August 8, 2022

**Re: Winfield Subdivision Phase 9
Updated Review of Drainage Report and Construction Plans
Prepared by Oscar Castillo, P.E. including Updated Report**

**UPDATED REVIEW OF CONSTRUCTION PLANS
AND
DRAINAGE REPORT PREPARED BY
OSCAR CASTILLO, P.E., PEUA
FOR
WINFIELD SUBDIVISION – PHASE 9**

1 PLAT
SCALE: 1" = 100'

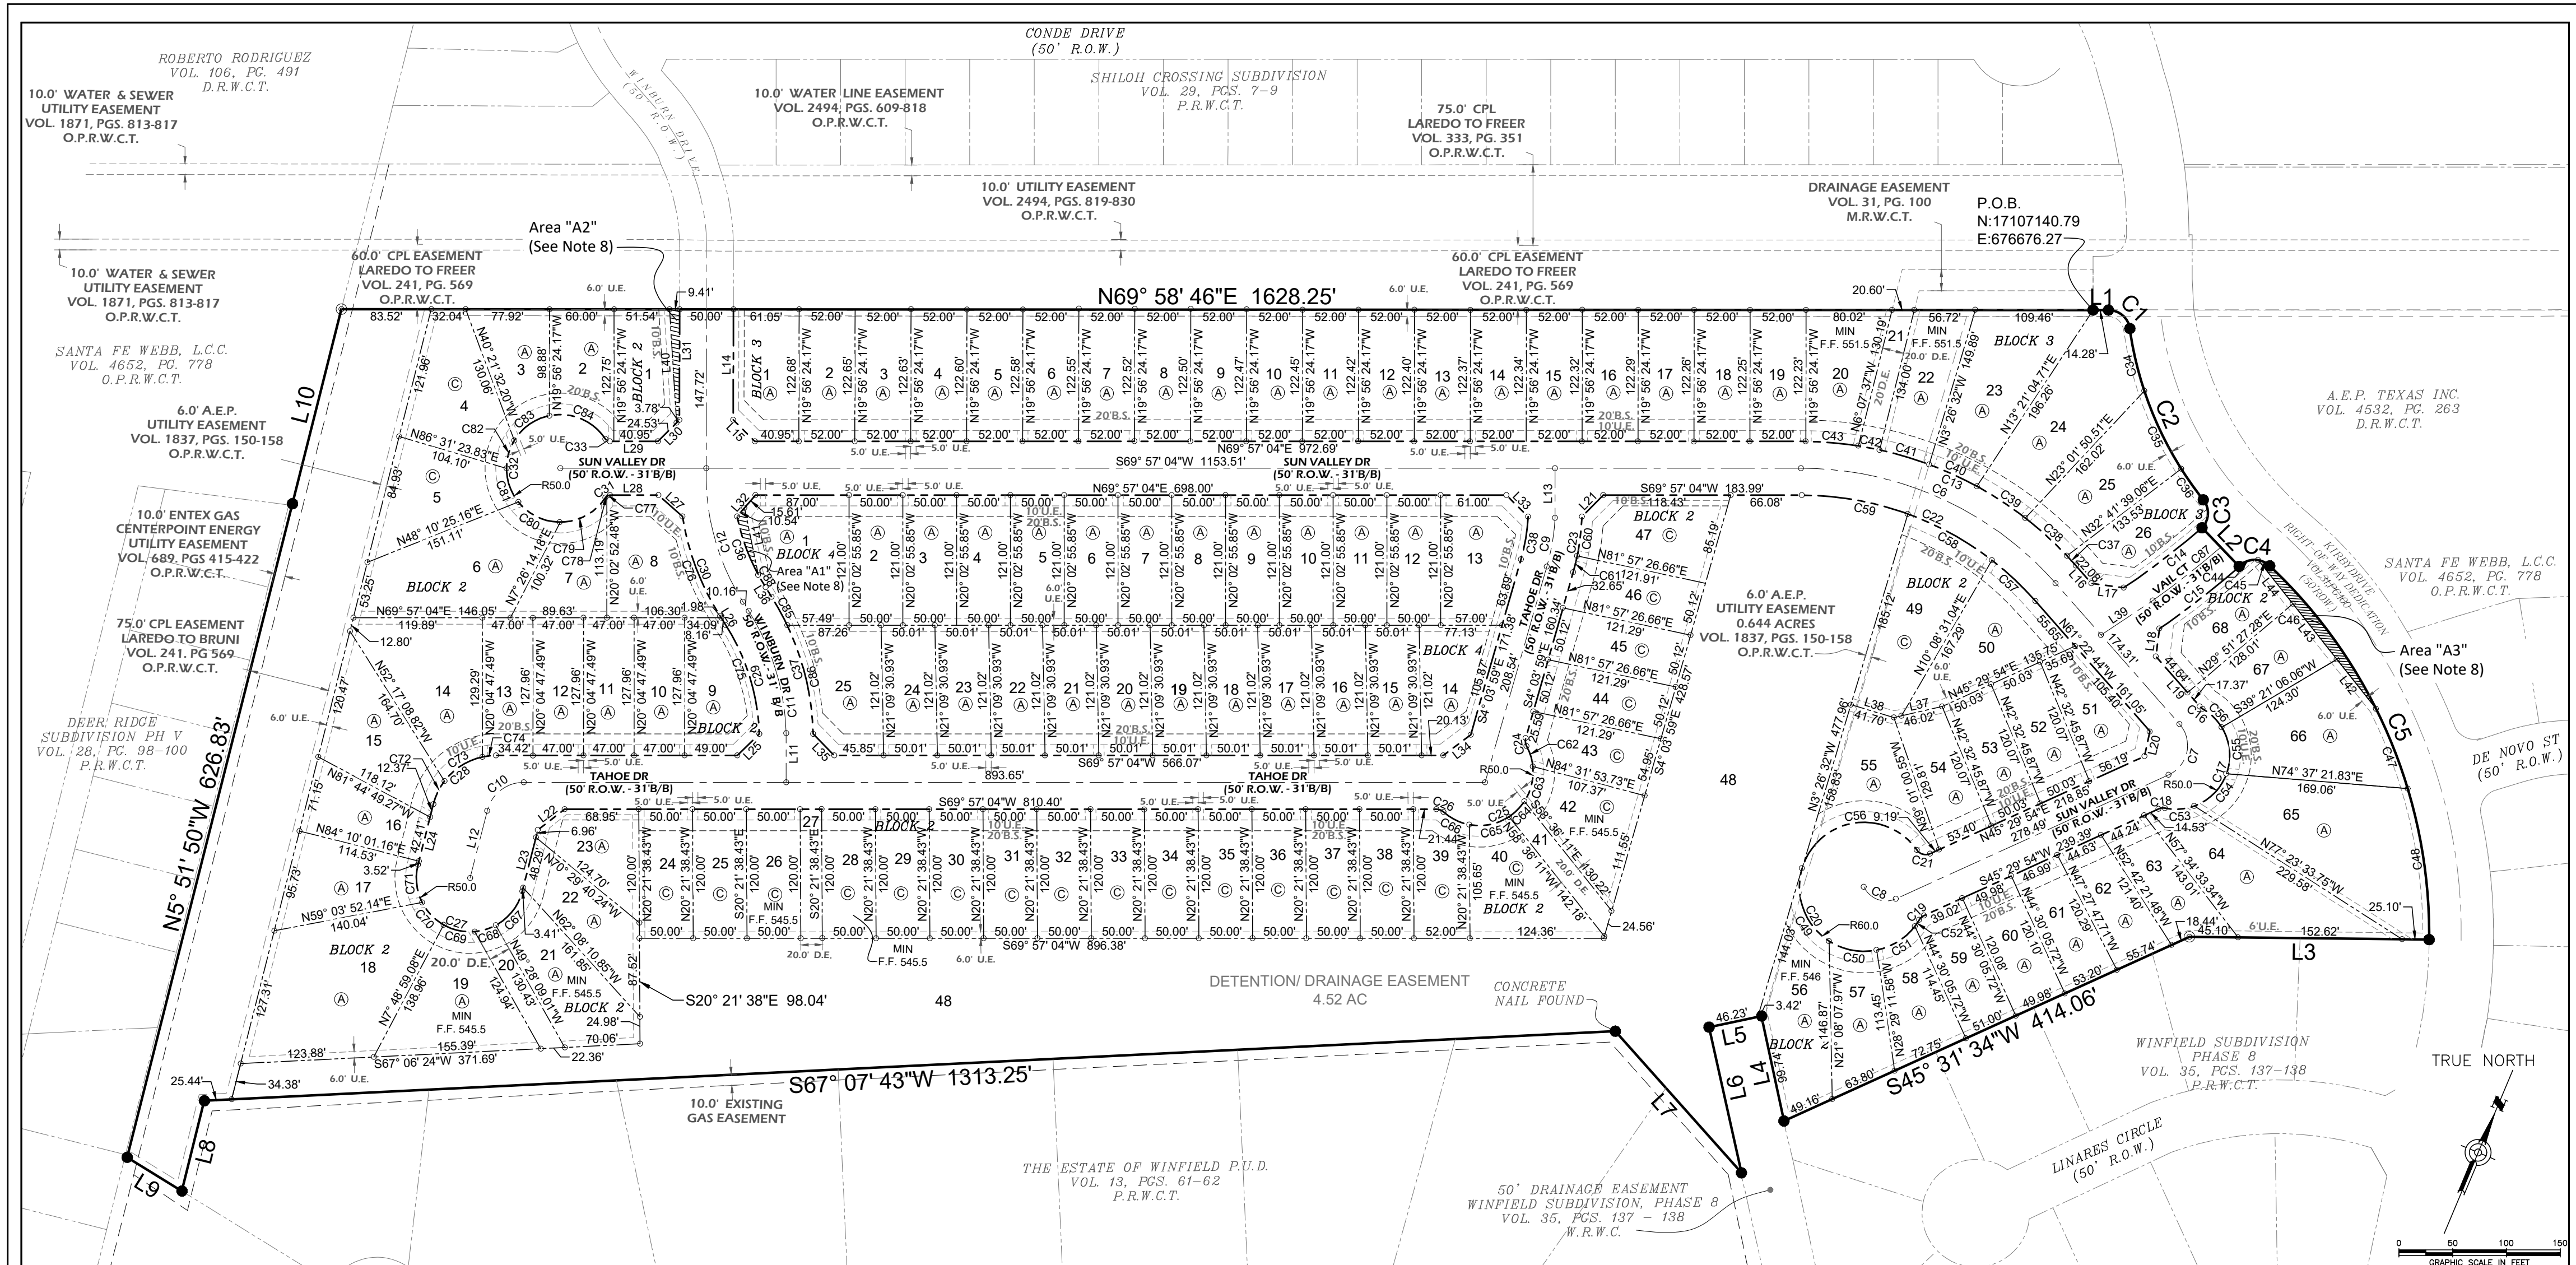
2. Sheet 1.1; Lot 18, Blk 2 is a drainage easement lot. It is recommended to confirm who will remain owner of this lot after development is completed;
3. Sheet 1.1; There is an island within cul-de-sac of Tahoe Drive. (Tahoe Drive cul-de-sac should've been a 60' radius as its length exceeds 150'). It is recommended to confirm who will maintain this island;

City of Laredo Park Ordinance 2008-O-058 uses the term open space to indicate potential park use. See sheet 9 of ordinance. No definition is given but it is implied to refer to park use. Peua plat does not address this as indicated on Seca masterplan.
